What We Heard Balwin and Belvedere Parks

Phase 2: Preliminary Design

November 2022

Balwin Park Design Concept

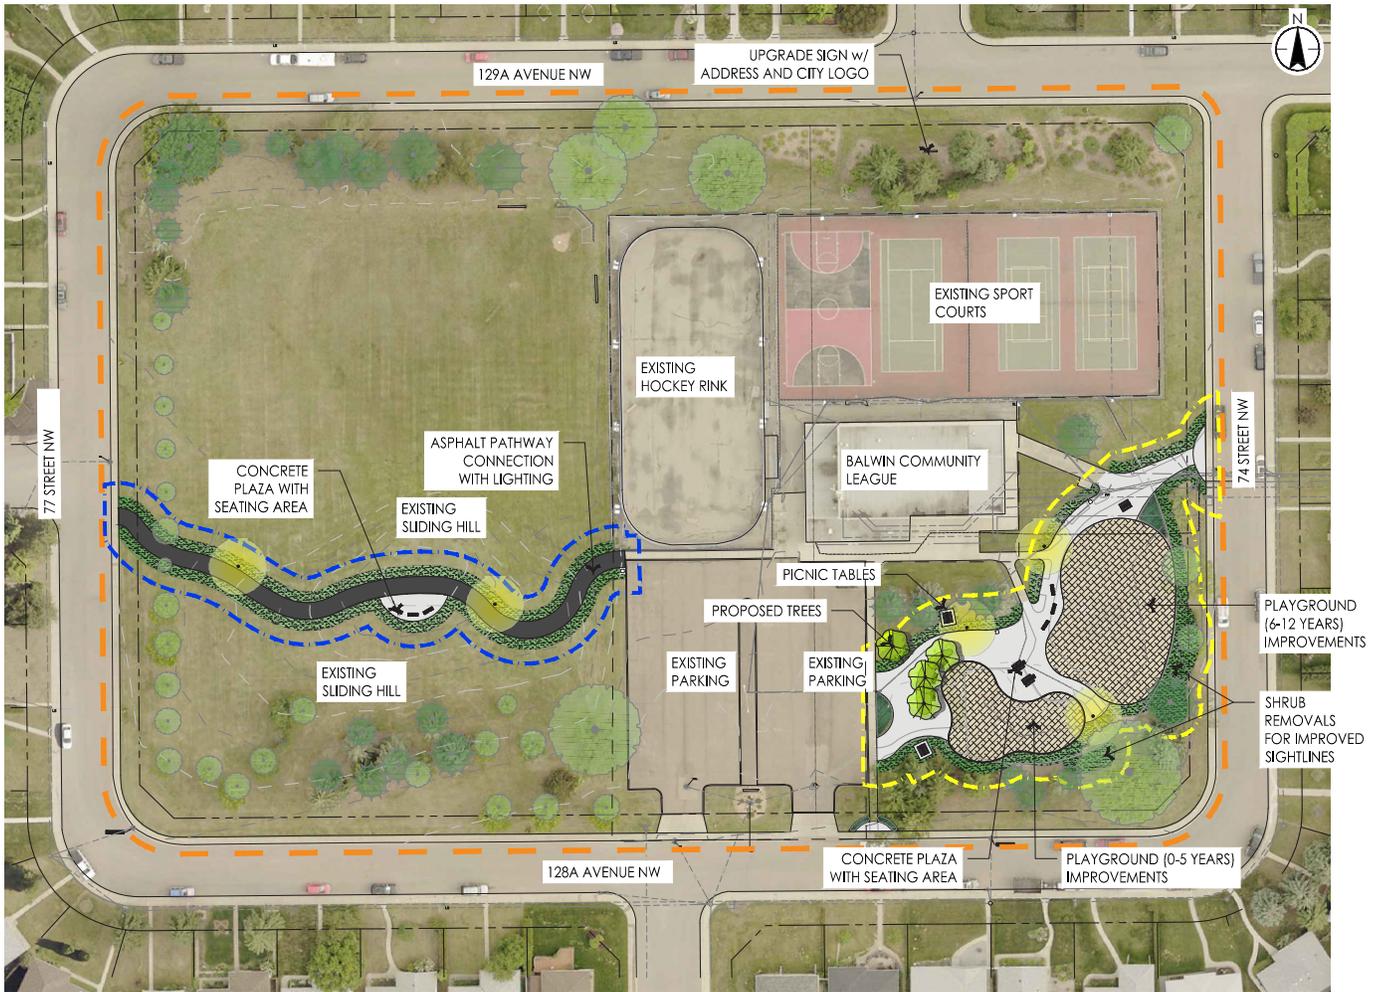
Two participants did not support upgrades. They did not feel the proposed upgrades reflected the wishes of the community, or that the upgrades were a proper use of public resources.

There were some open-ended comments provided about these proposed upgrades. One comment expressed general support and also suggested public art at the parks. Some comments expressed concern about building pathways over green space. There were a couple specific suggestions including a caged basketball court to prevent balls leaving the court and outdoor exercise equipment. One comment also expressed concern about losing the sledding hill and light pollution. *Please note the sledding hill at Balwin Park is proposed to remain.*

- + Review the placement of the pathway and plaza areas in relationship to sliding hill areas
- + Add a waste receptacle by the seating area on the top of the hill.

Zoie Gardner Park Design Concept

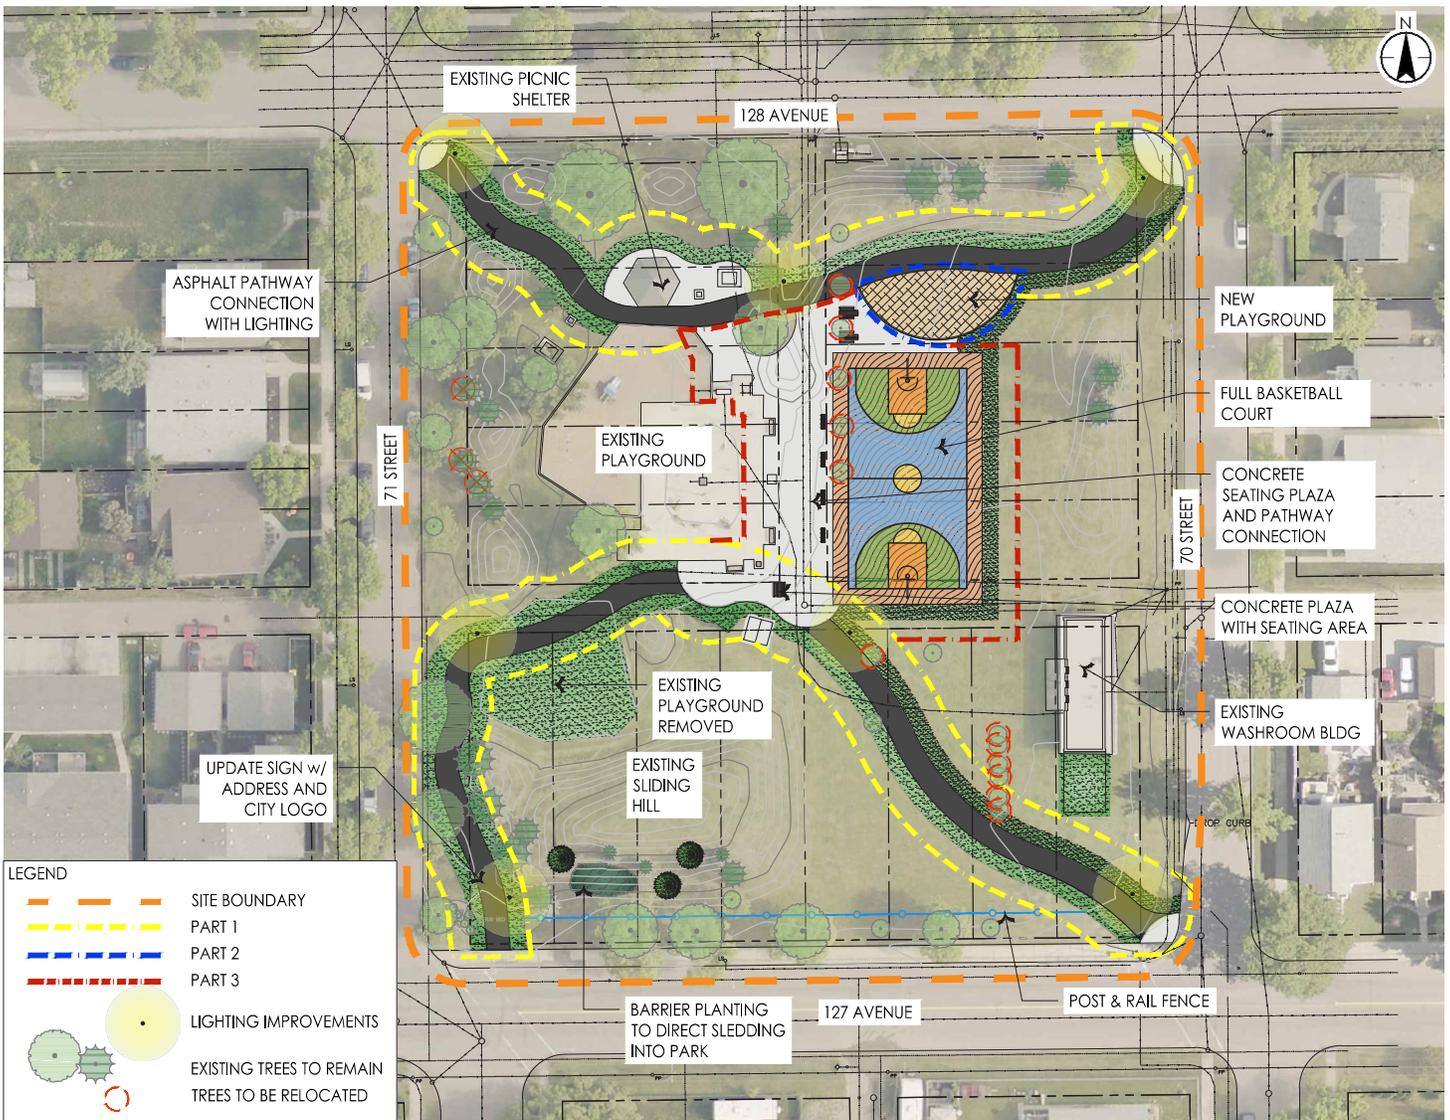
Two participants did not support upgrades. They did not feel the proposed upgrades reflected the wishes of the community, or that the upgrades were a proper use of public resources.

Additional suggestions about the proposed upgrades were provided by some participants. Many reiterated general support for the proposed upgrades. Suggestions for improvement were focused on providing activities and equipment for older children. These suggestions included expanding the spray park, playground equipment for older children (7–12 year olds), maintaining open space, and building an ice rink. There was also a suggestion for a fenced dog park. One participant recommended moving the multi-use court further away from the spray park to provide space between young children and teenagers. Two responses expressed concern about safety and suggested security cameras and increased police presence.

- + Review location of the multi-use court and increase greater separation between playground, splash pad and multi-use court
- + Potential modification to layout of the multi-use court to a half court.
- + Review potential use of the fencing around the multi-use court

Belvedere Park Design Concept

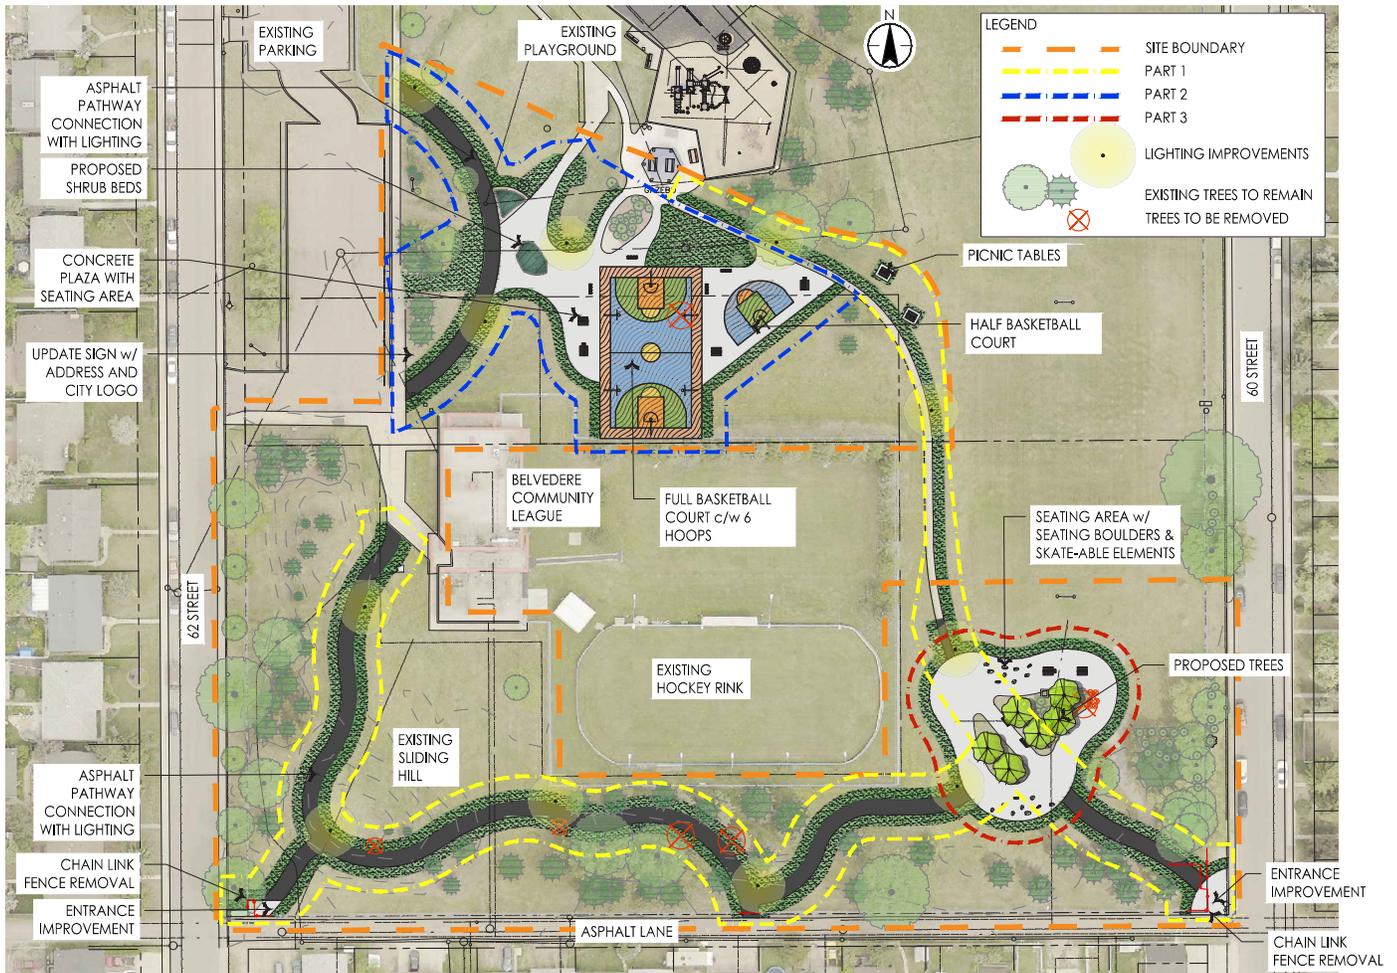
Two participants said they do not support any of the upgrades. They did not feel the proposed upgrades reflected the wishes of the community, or that the upgrades were a proper use of public resources.

There were a number of additional suggestions about the proposed upgrades. Many comments expressed general support for the proposed upgrades. Some comments were focused on safety and improving visibility and sightlines by removing more trees, planting shrubs instead of spruce trees, and removing entrances from the alleyway. There were a few comments expressing opposition to the proposed skatepark due to the additional concrete. One comment suggested additional police presence at the park. Other suggestions included adding a spray park, fire pits, and improved wheelchair accessibility.

- + Review visibility triangles between outdoor shelter and play area to reduce blind spots. This could include additional tree removals and tree pruning.
- + Multi-use court focus on basketball, pickleball, ball hockey
- + Adult activities, jumbo chess set or similar games
- + Review potential seating area within proposed preliminary to reflect busier areas within the park
- + Modification four entrances into the park to allow greater access individuals of all abilities
- + Review the placement of the pathway in relationship to sliding hill areas

Braids Park Design Concept

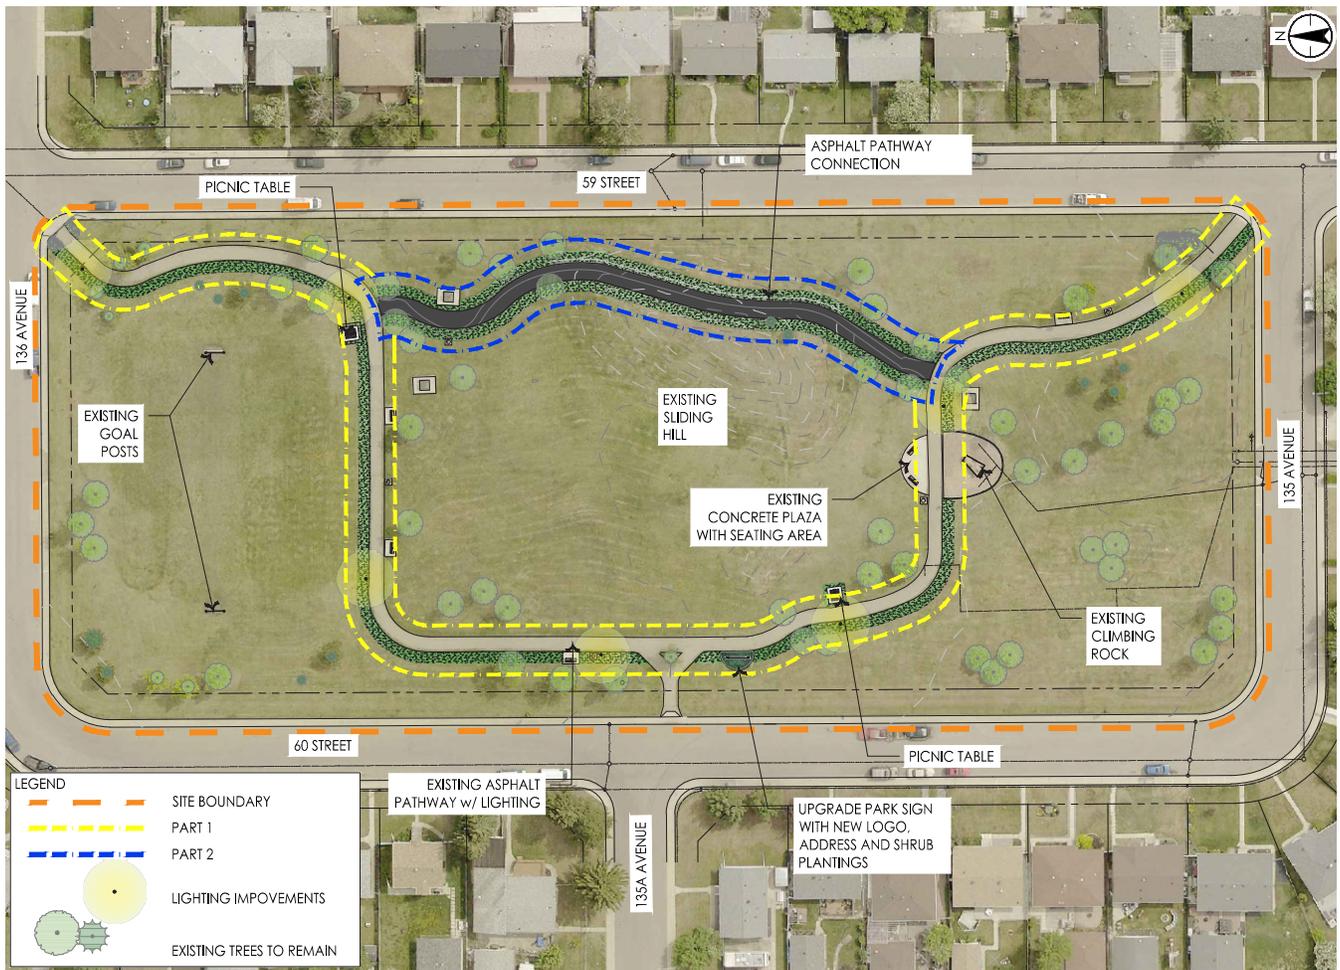
Four participants said they do not support any of the upgrades. One did not feel the proposed upgrades reflected the wishes of the community, although did not specify why, and another did not feel the upgrades were a proper use of public resources. Two participants expressed frustration over the loss of green space.

There were some additional comments provided which expressed both support and opposition for the upgrades. There were a few comments expressing opposition to the asphalt pathways. There were also requests for bathrooms, garbage cans, picnic tables and additional police presence. Another comment expressed concern about losing the sledding hill (it may not have been made clear to some participants that the sledding hills will remain).
